SERVICE BULLETIN

SB059-0801

Subject: Legacy Rudder Trim Tab Reinforcement
Date: 23rd of August, 2001
Ref: Construction Manual, Attached pages
Pages: 1 (2 sides)
Status: Mandatory Compliance

Fig.1

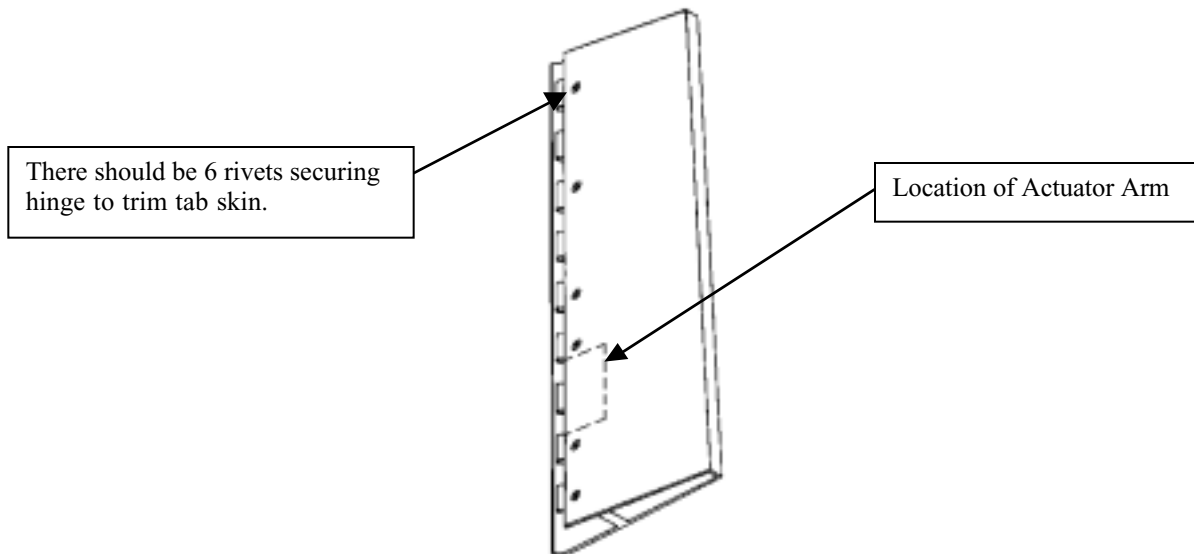
The Legacy rudder trim tab secures to a hinge with structural pop rivets (refer to figures below). Legacy kits with serial numbers 104 through 138 are lacking two of these rivets. There should be a total of 6 rivets securing the trim tab

Inspect your rudder trim tab and count the number of rivets securing the skin to the hinge. If there are only a total of 4 rivets (not counting the two rivets securing the actuator arm to the hinge) you must comply with the service bulletin.
